Interview Summary	Application No.	Applicant(s)	
	10/618,133	LI ET AL.	
	Examiner	Art Unit	
	Matthew O. Savage	1724

U.S. Patent Appl. Ser. No. 10/618,133
For: APPARATUS AND METHOD FOR CONTINUOUS
DEPYROGENTATION AND PRODUCTION OF
STERILE WATER FOR INJECTION
Filed: July 11, 2003
Our Ref: ARA-US-P1

**PROPOSED AMENDMENTS TO THE CLAIMS
IN RESPONSE TO THE FINAL OFFICE ACTION**

FIG.3

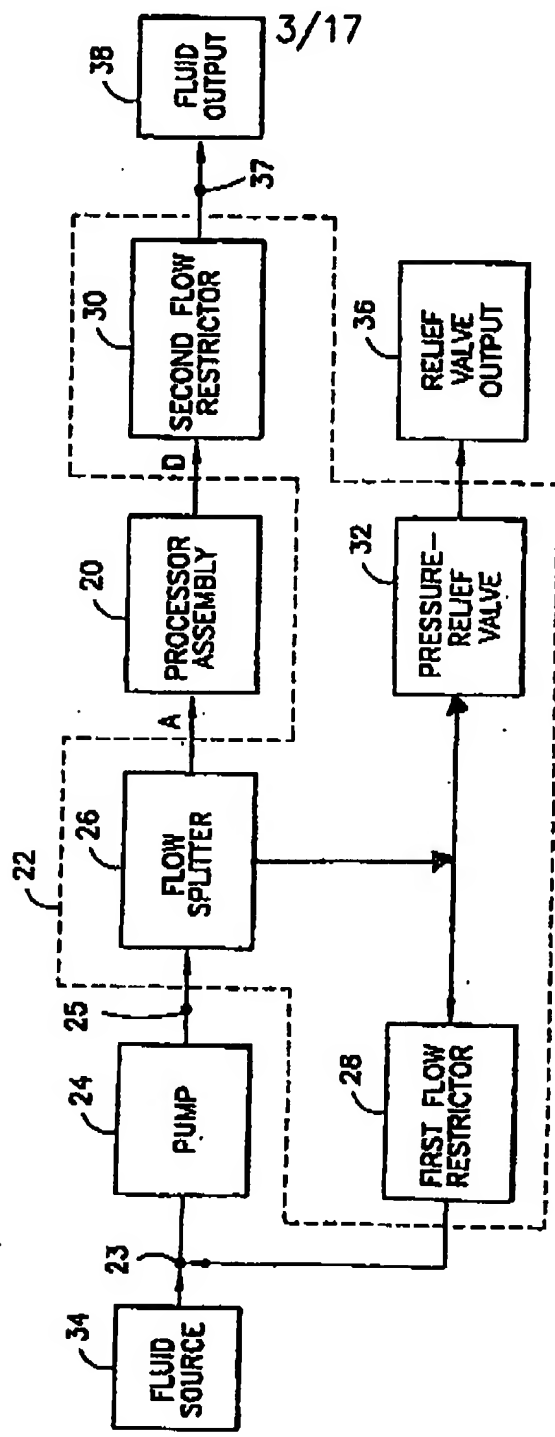
On page 2, par. 2 of the Office Action, the drawings were objected to under 37 CFR 1.83(a) as not showing the spring-loaded adjustable pressure relief valve recited in claim 12 (actually claim 9). We direct Examiner's attention to FIG. 3 showing pressure relief valve 32 and the specification which states:

On page 3, par. 1-2 of the Office Action, the Examiner objected to the proposed amendment of FIG. 3 on the ground that the added material (i.e., a pressure relief valve having a single inlet and single outlet) was not supported by the original disclosure. Later on in par. 4, the Examiner stated that the proposed amendment to FIG. 3 outlining the process control system 22 was approved.

However, Applicants did not propose any amendment to process control system 22 in FIG. 3. We also noted that on the Replacement Sheet 3/17, the Examiner approved the proposed amendment in FIG. 3 regarding the pressure relief valve. We have attached a copy of Replacement Sheet 3/17. We ask if the Examiner could please clarify the status of the Applicants' proposed amendment to the pressure relief valve 32 in FIG. 3.

okay to enter.
W3
